ITEM: 6.2	REPORT SUMMARY MINOR VARIANCE APPLICATION FILE NUMBER A007/24
-----------	---

MINOR VARIANCE APPLICATION FILE NUMBER A007/24

CITY WARD #:	2
APPLICANT:	Deepak and Leena Chopra
AGENT:	Lasonne Engineering Ltd. (Daniel Falzon)
PROPERTY:	15 Modesto Valley Court, Woodbridge
ZONING DESIGNATION:	See below.
VAUGHAN OFFICIAL PLAN (2010) DESIGNATION:	Vaughan Official Plan 2010 ('VOP 2010'): "Low-Rise Residential".
RELATED DEVELOPMENT APPLICATIONS:	None
PURPOSE OF APPLICATION:	Relief from the Zoning By-law is being requested to permit a proposed cabana, two pavillions (shown as Pavillion A and Pavillion B on the plan submitted with the application) and reduced rear yard soft landscaping requirements.

VARIANCE #9

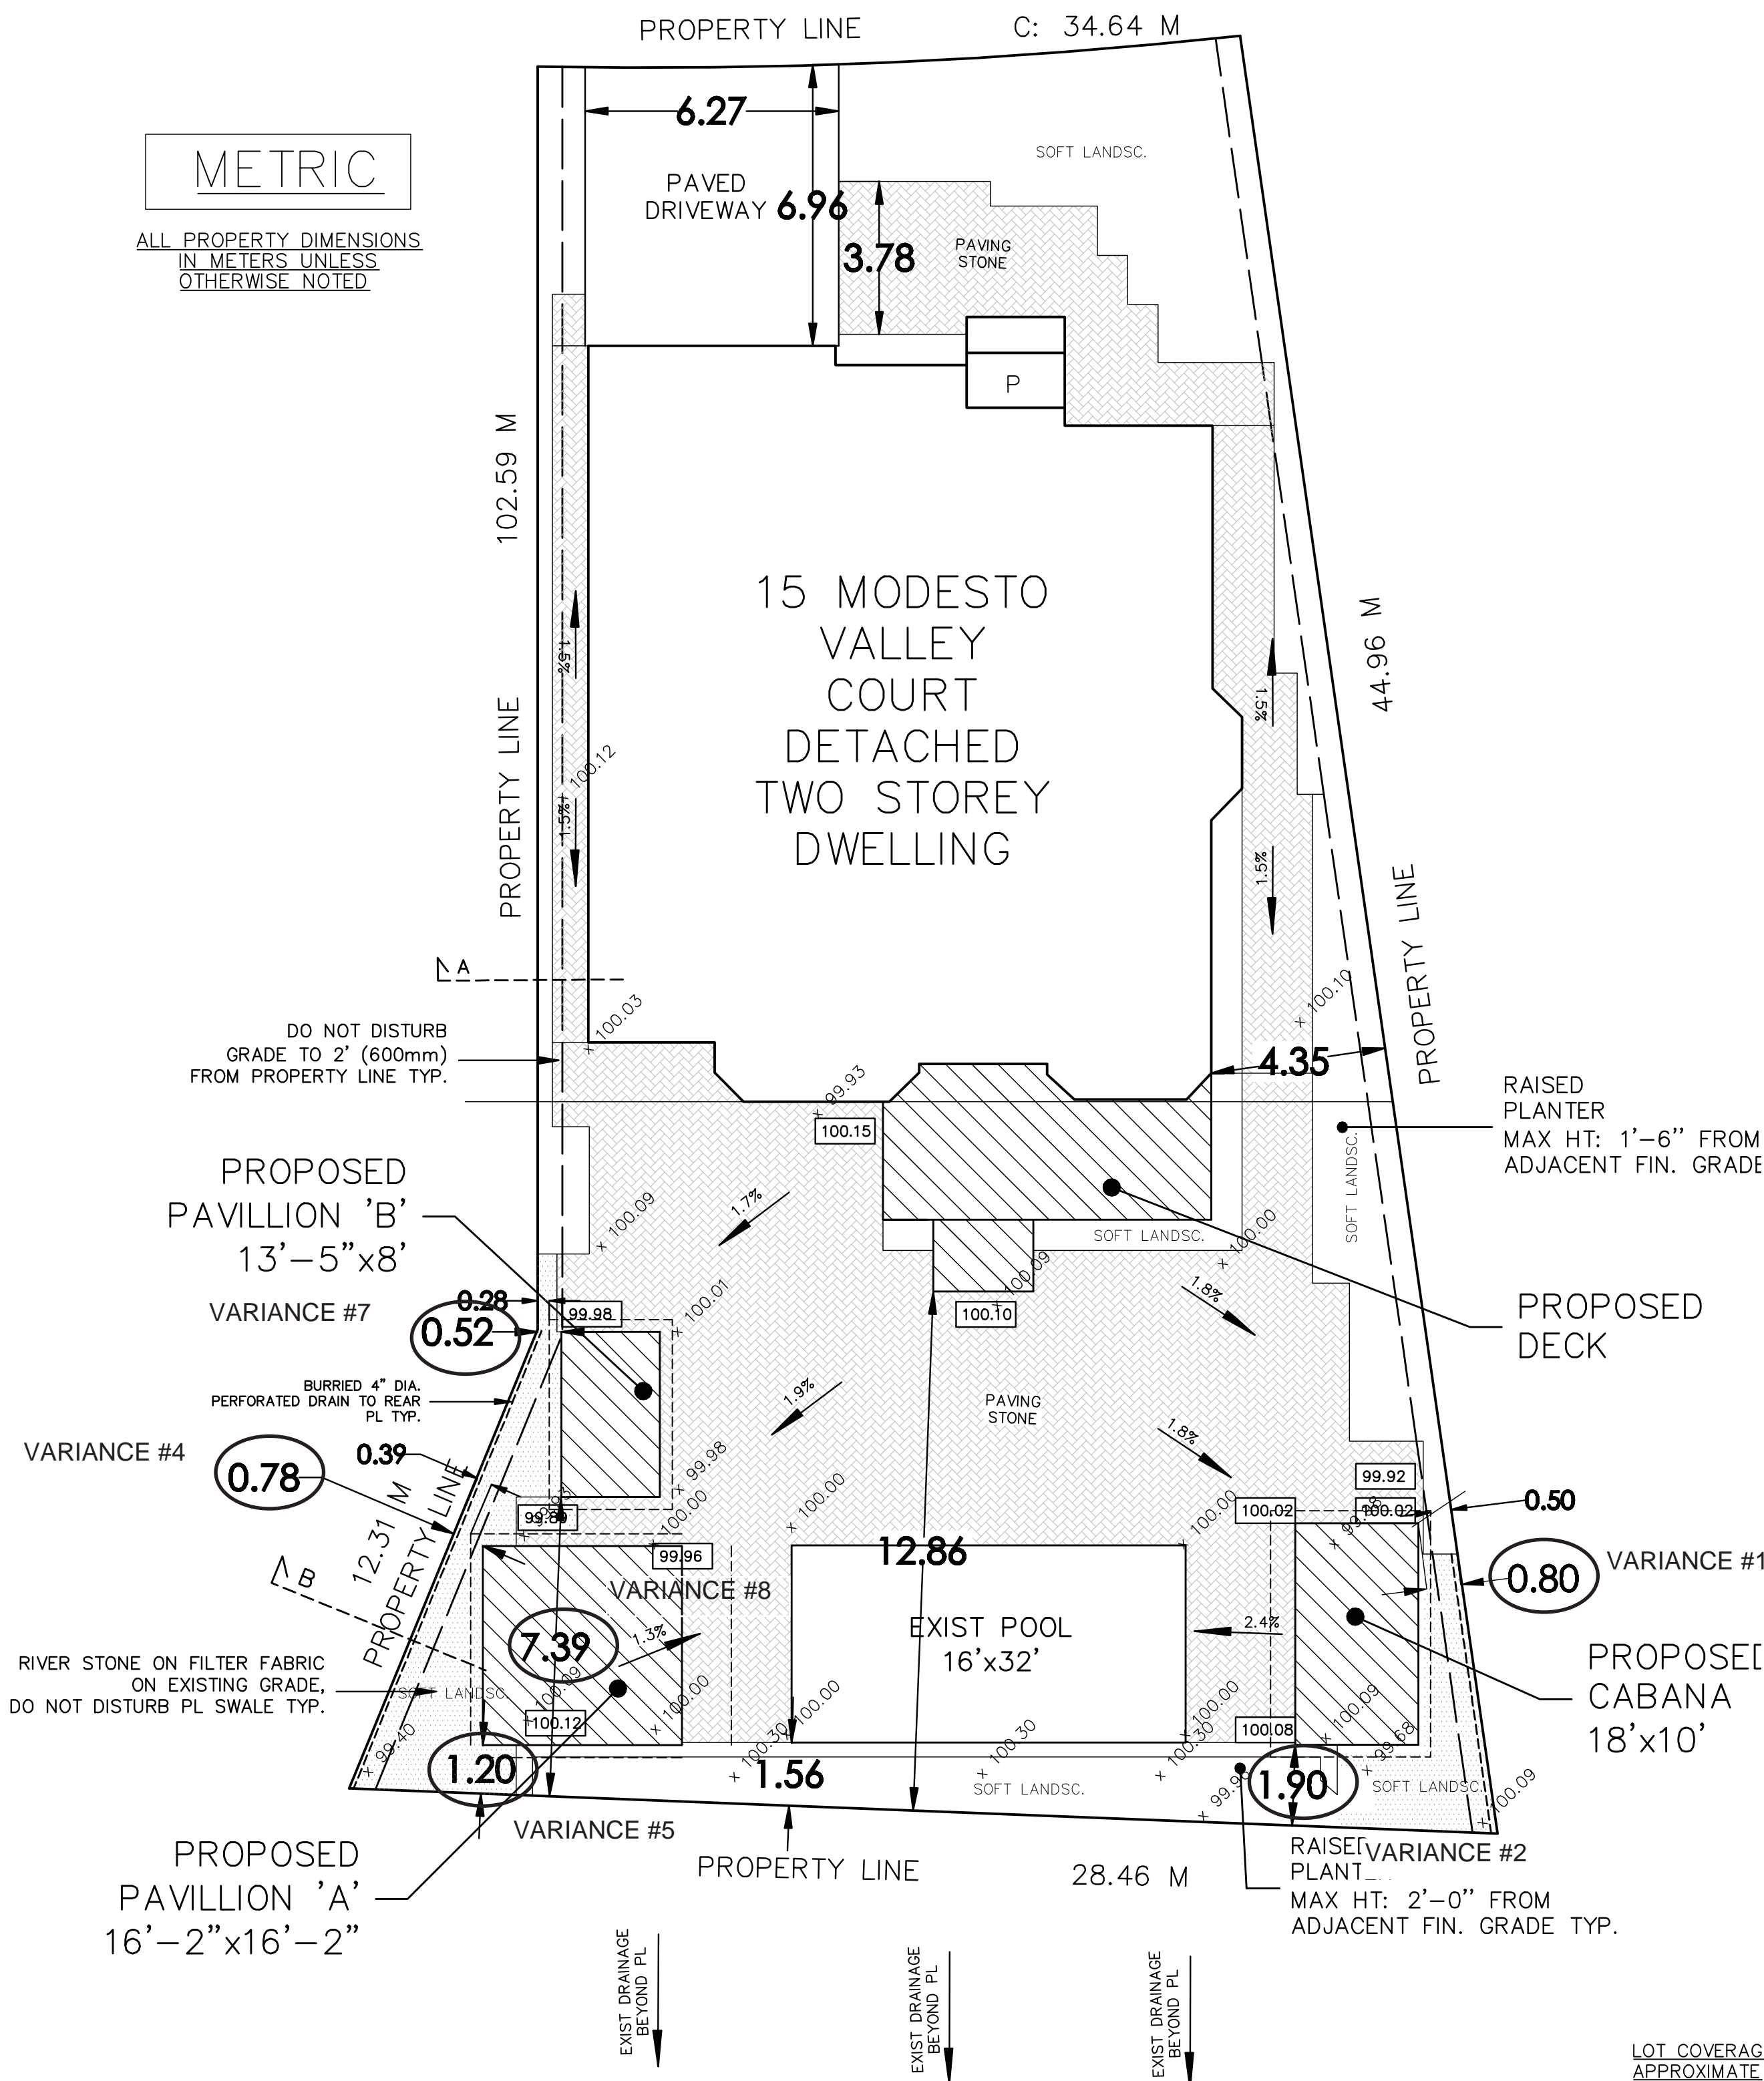
Development Planning Staff have no objection to Variance 9 to permit a reduction in the required minimum soft landscaping in the rear yard. The proposed 16.44 m² reduction is relatively modest from a visual perspective when considering the entirety of the fairly large rear yard (423.76 m²). There is a fair amount of soft landscaping around the rear yard's perimeter (118.56 m²). More particularly, a slightly raised planter box containing trees and a strip of river rock run along the southern interior side lot line. River rock, yew and boxwood plantings, and additional trees run along the northern interior side lot line. Along the rear lot line (abutting the EP Zone), there is a raised planter bed containing mulch, trees, and boxwood plantings along the entire rear lot line which helps provide a natural buffer between the existing swimming pool (and accessory structures) and the abutting open space area. At the request of Development Planning Staff, the applicant has agreed to increase the amount of soft landscaping along the southern interior side lot line and along the rear perimeter of the existing dwelling. Development Engineering Staff have also reviewed the application and do not have any concerns regarding drainage. As such, Development Planning Staff are of the opinion that the proposed reduction in rear yard soft landscaping is desirable and appropriate for the development of the land and does not adversely impact the surrounding neighbours or existing character of the existing neighbourhood.
